## ADDENDUM

**ADDENDUM NO.:** 04  
**PROJECT NAME:** Emergency Medical Services (EMS) Addition  
**PROJECT NO.:** 07215  
**CONTRACT NO.:** C1611  
**DATE OF ISSUE:** July 31, 2024

### NOTICE OF CHANGES, MODIFICATIONS, OR CLARIFICATIONS TO CONTRACT DOCUMENTS

SHEET NUMBER  
T701

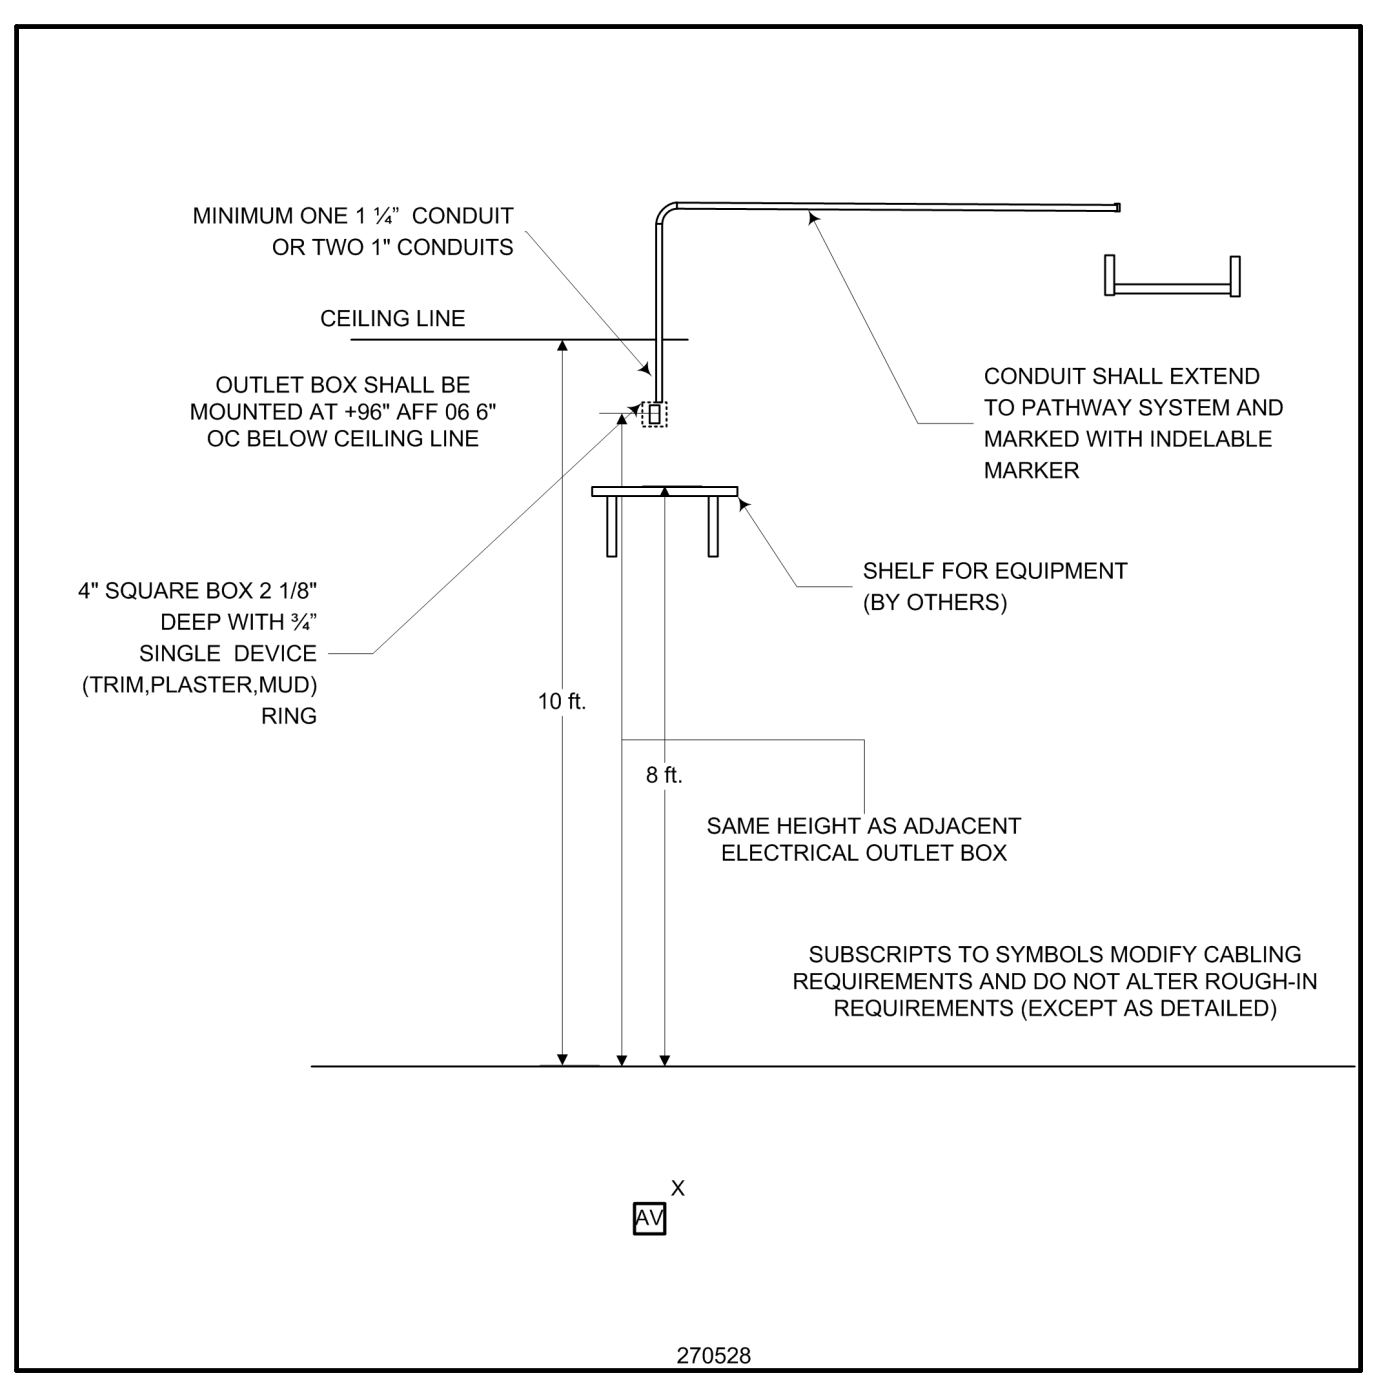
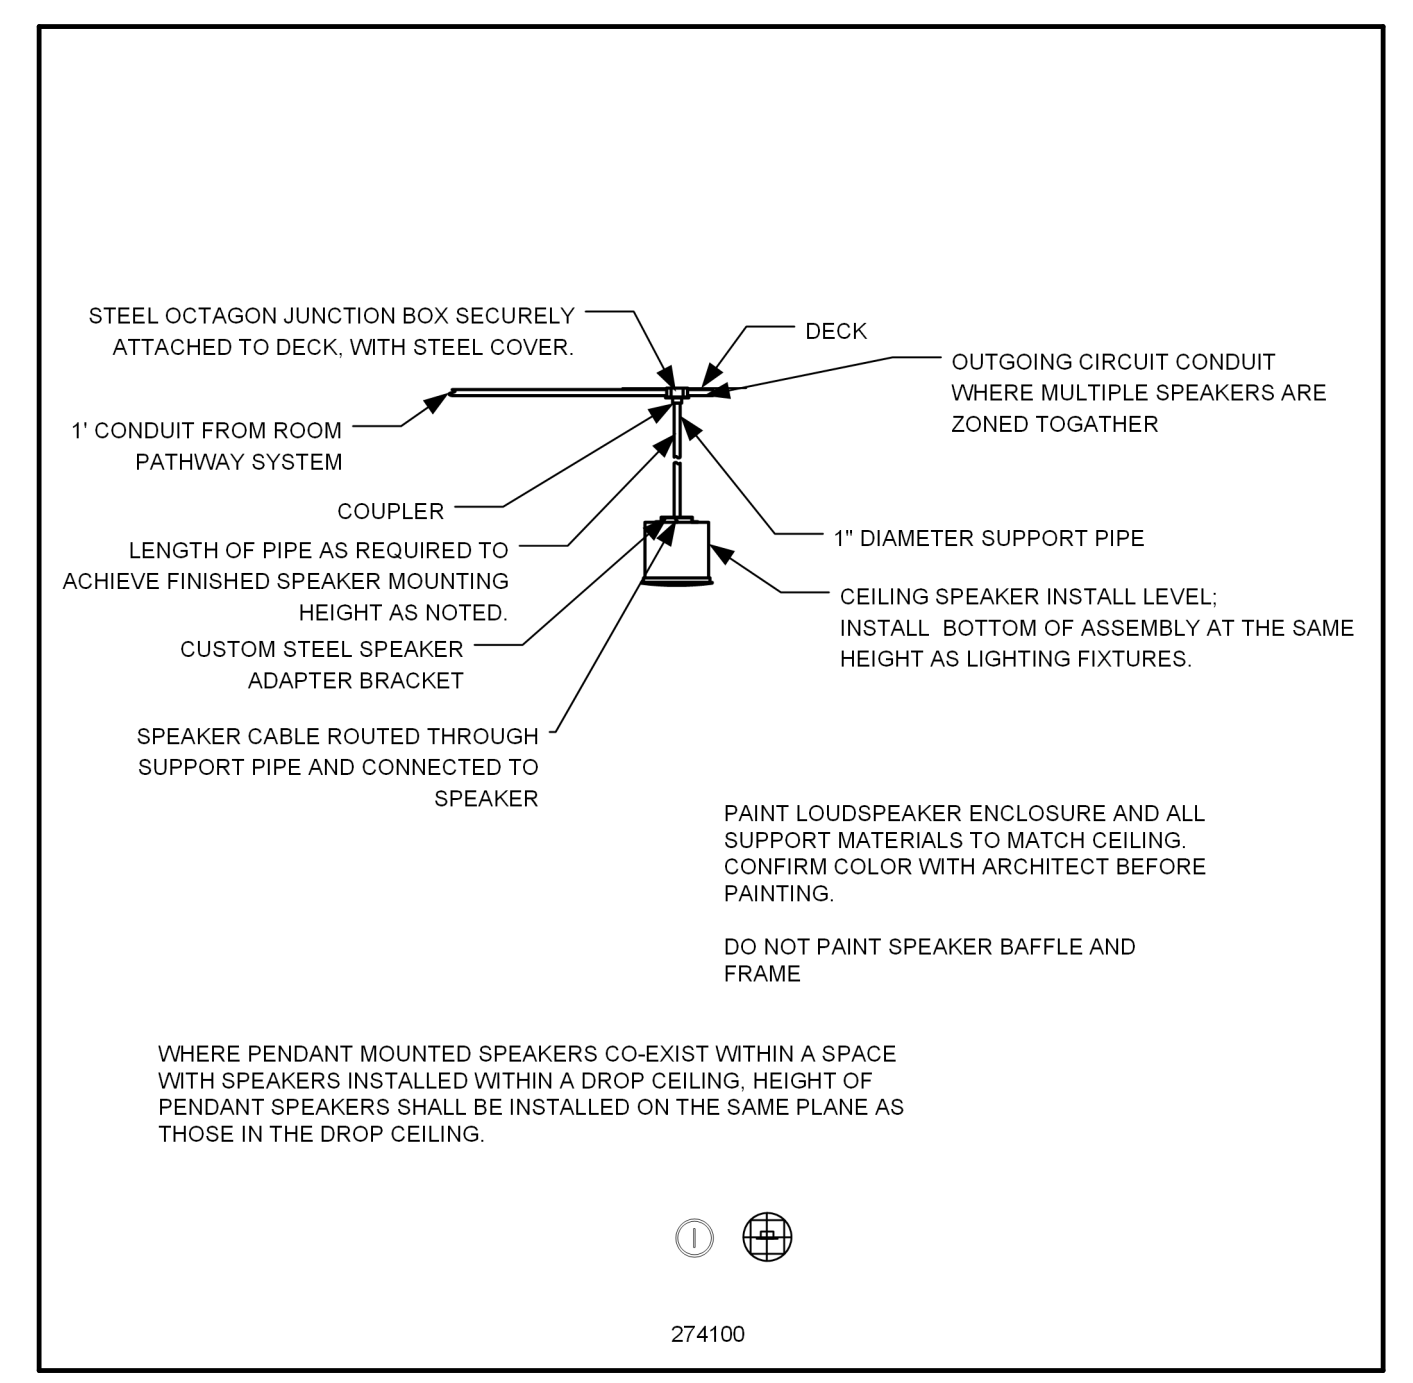
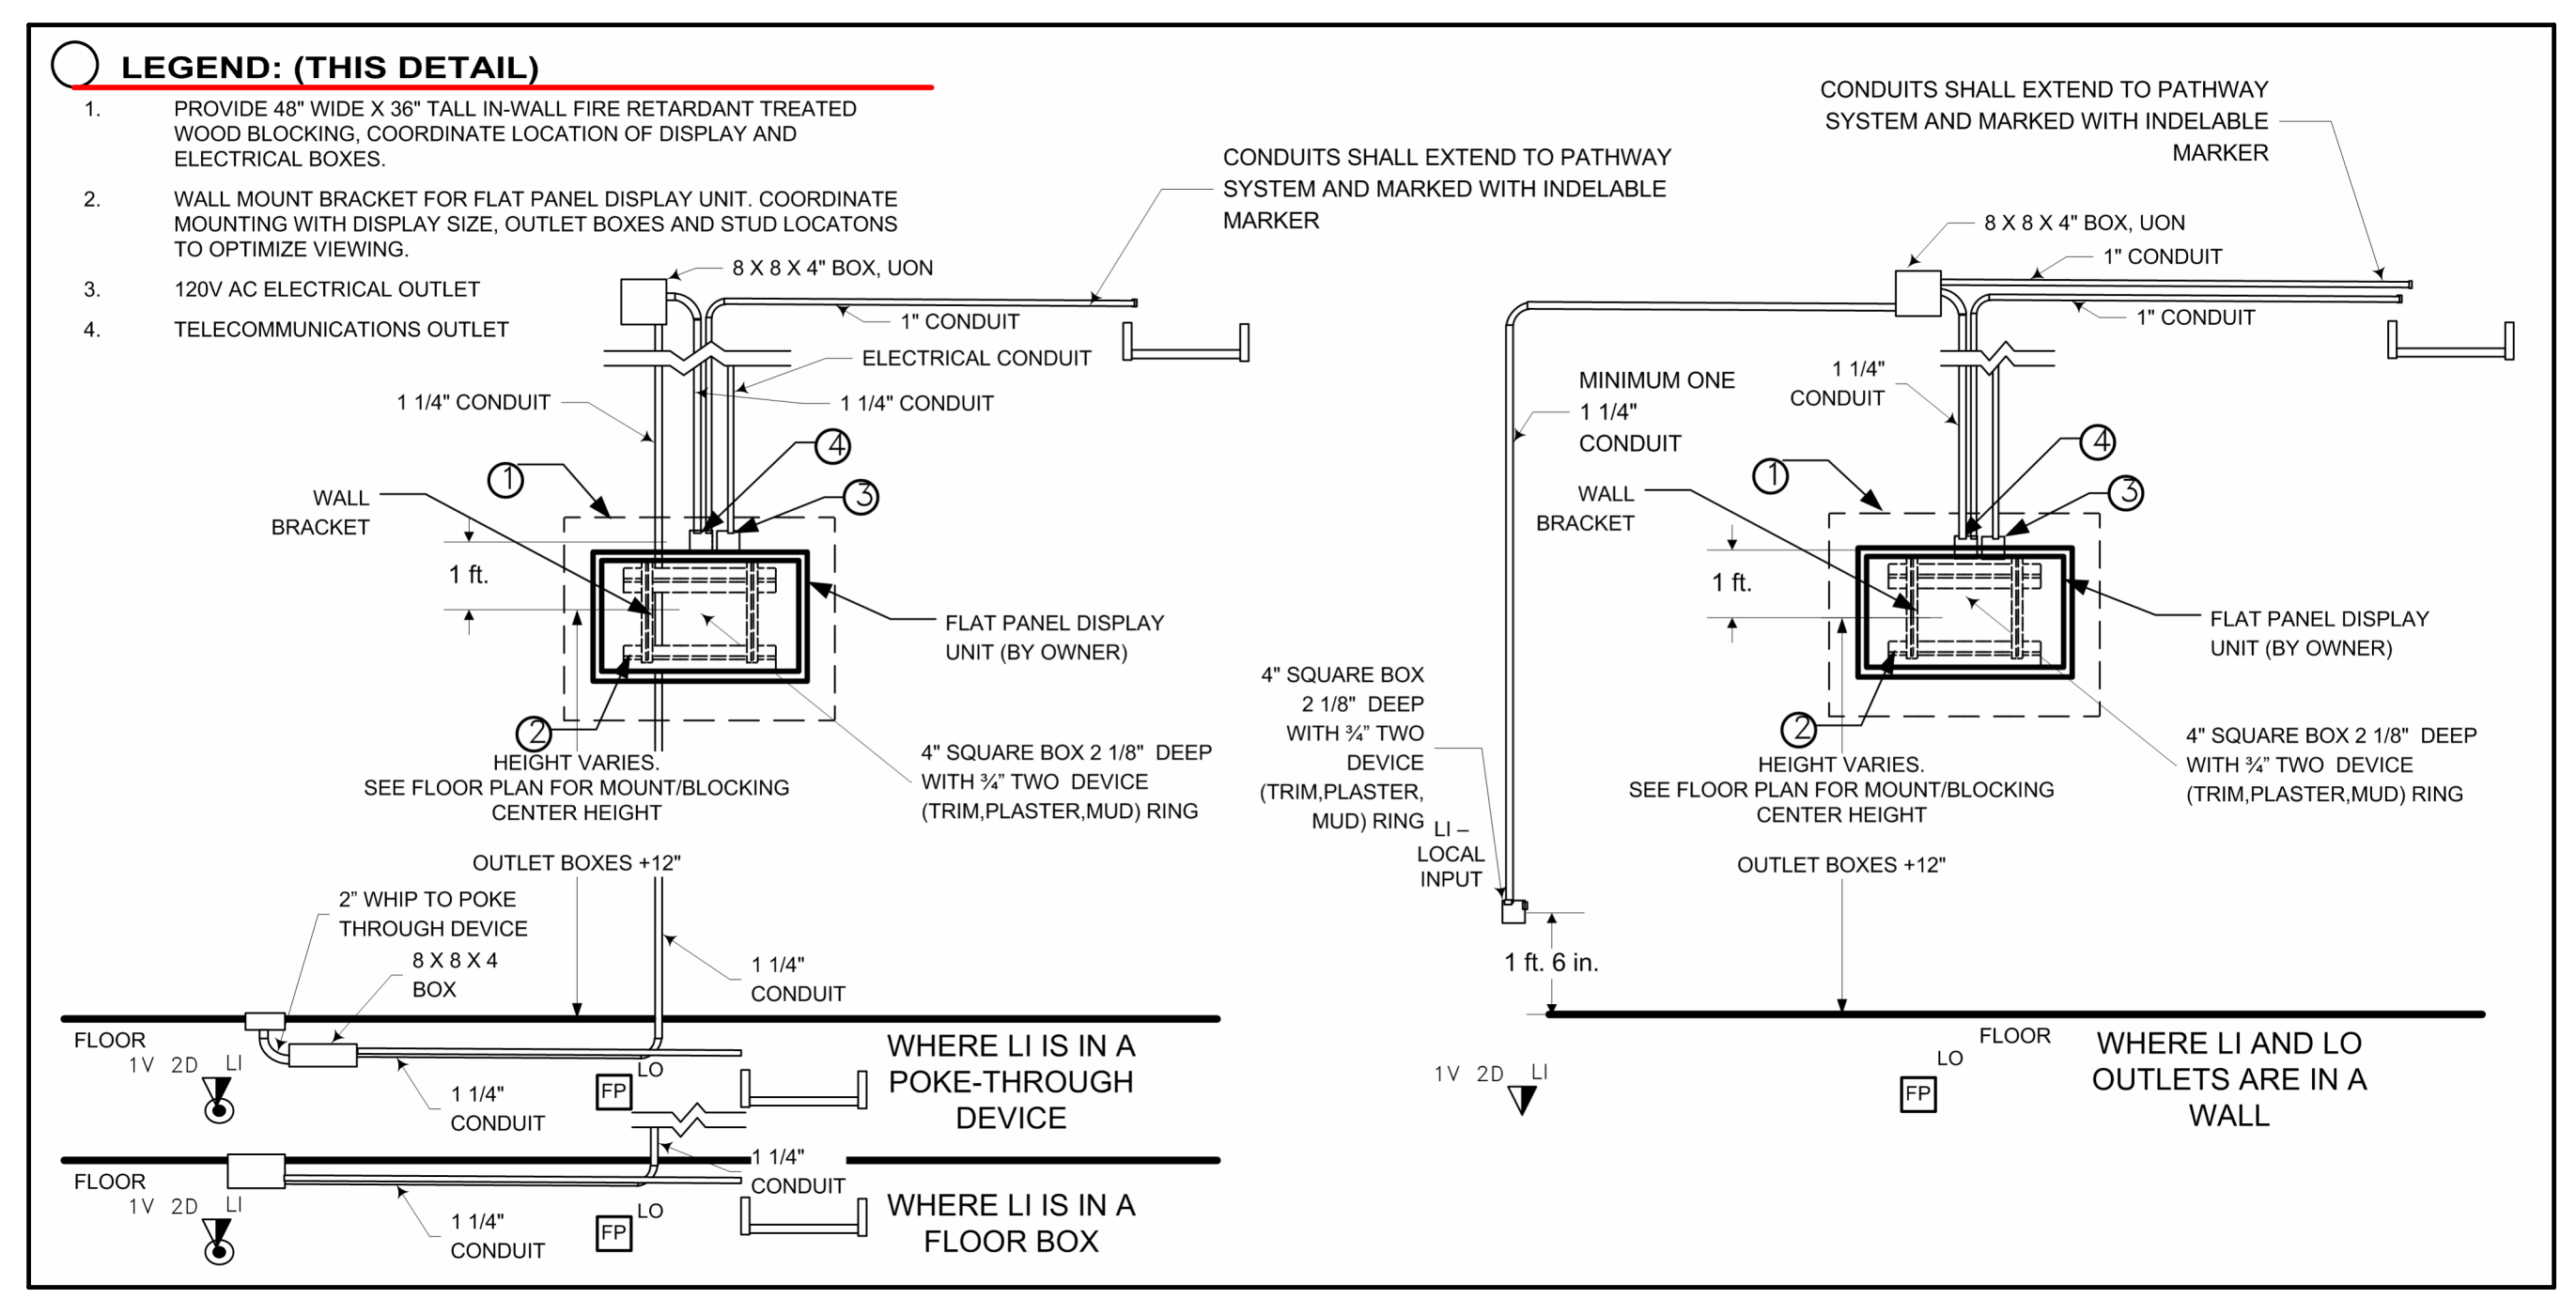
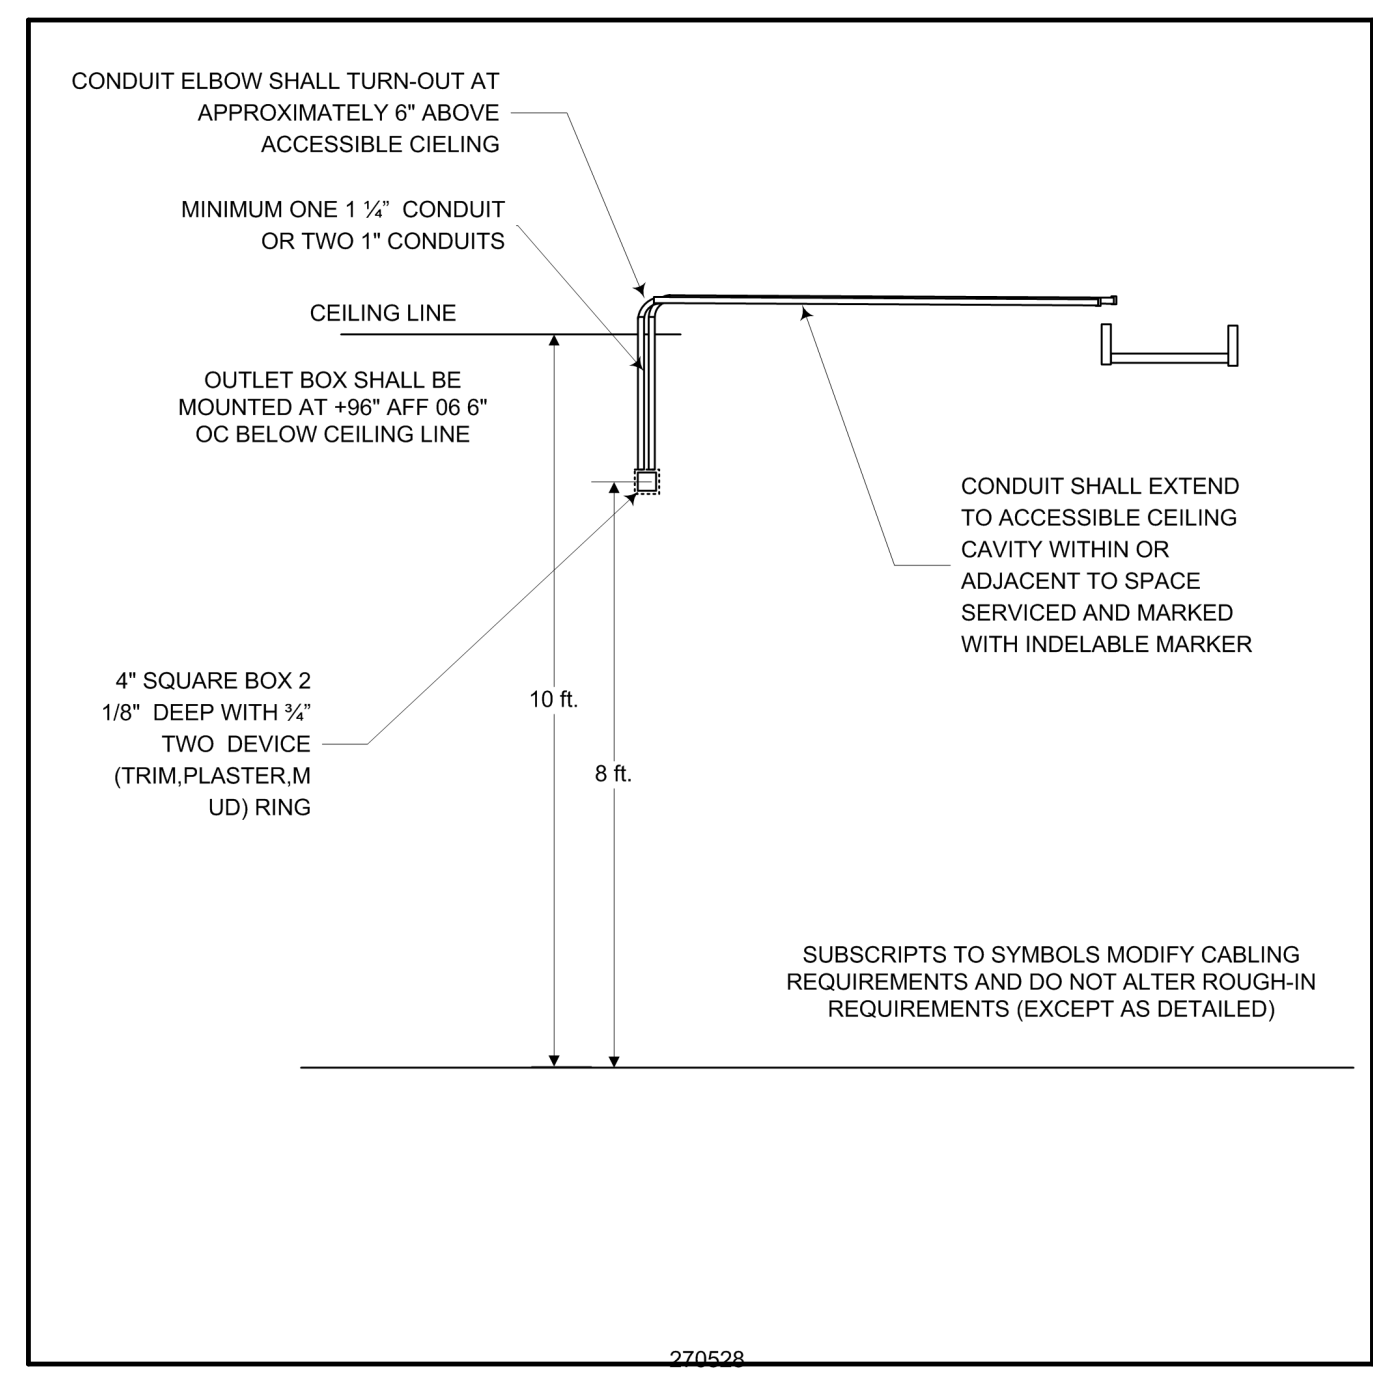
- Change 38 REVISED** Drawing No. T701 – Updated Details 7 & 10.  
**Change 39 REVISED** Drawing No. T702 – Updated Details 3, 4 & 9. Added Detail 10.  
**Change 40 REVISED** Drawing No. T771 – Updated Details 3, 6, 7 & 8.  
**Change 41 REVISED** Drawing No. FA001 – Updated Fire Alarm Riser Diagram to state correct location of existing fire alarm control panel.
